C1967 The Grange, Westergate (Designer reply in red)

Engineers Comments Regarding Surface Water Drainage - Condition 10

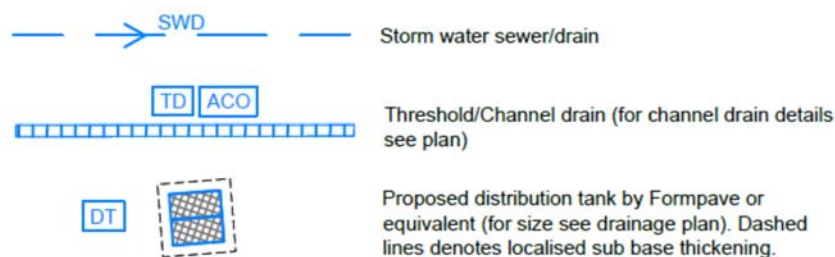
- a. Please include pipe gradients.
- b. Diffuser blocks should be set above the 1 in 10 year +40% critical storm event. They are currently set below the formation level of the permeable paving (diffuser inverts at 9.350 – permeable paving formation at 9.370). These should also be located a minimum of 5m from all controlled structures, see point 3. Please correct.

The proposed diffuser block has been relocated minimum 5m away from the proposed structures. The proposed diffuser tanks act as an outlet (discharge) connection into the subbase formation. We do understand that incoming pipe IL should be set above the 1 in 10 year + 40% CC level for the traditional soakaway system, however the proposed surface water runoff will be discharged into the voided subbase and therefore to achieve this, the proposed subbase IL will need to be dropped by approx. 300mm. This will make the proposed subbase 600mm deep and due to the associated costs not viable. We could propose using a traditional soakaway system however, noting the groundwater levels surface water runoff will therefore need to be attenuated and discharged into the onsite foul drainage system. By doing this, there is a risk of the proposed SW discharge into foul drainage network being refused by statutory undertaker.

The proposed drainage system has been designed so the surface water level for the 1 in 10 years + 40% is below the proposed access points (rodding eye) ILs.

Furthermore, the proposed FFL has been set at min. 300mm above the top of the proposed voided subbase and the maximum surface water level for the 1 in 100-year rainfall event + 40%CC + 10% UC.
